SIB 63 04 20

RECALL 20V-528: HEADLAMP (SCENIC-LIGHT) LENS

This Service Information Bulletin (Revision #1) replaces SI B63 04 20 dated August 2020.

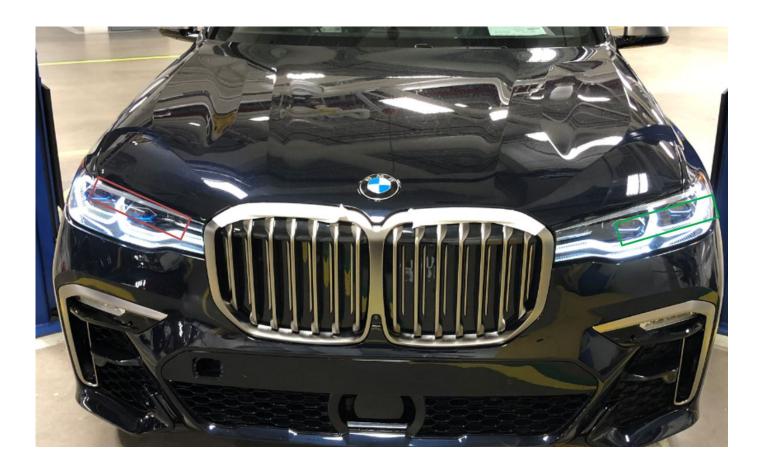
The left and/or right headlamp may contain a specific version of the "scenic-light" lens which allows for blue light to illuminate. This lens may not meet a Federal requirement, because the blue light is outside of the allowable light color spectrum.

The incorrect headlight(s) may have been installed during production.

In the following procedure, the color of **light emitted** from the "scenic light" on the "X shaped finisher" inside the headlight will be inspected. The color of the plastic finisher is NOT being inspected and WILL be blue (which indicates a laser light); this is OK.

- 1. Adjust the headlight switch so that only the parking lights (halos) are set to "on". Ensure the headlights are turned OFF. Inspection will not be possible with the headlights on.
- 2. nspect the color of the light emitted from the X shaped finisher within the headlight. The photo below shows an example of a vehicle with one blue light on the passenger side (NOT OK) and one white light on the driver side (OK).

Inspect the headlights and replace if necessary.

3. Are BOTH headlights emitting a white light?

Yes: No correction is needed

**No:** Replace whichever headlight is emitting the blue light following the applicable repair instructions within ISTA for the model of vehicle being repaired.
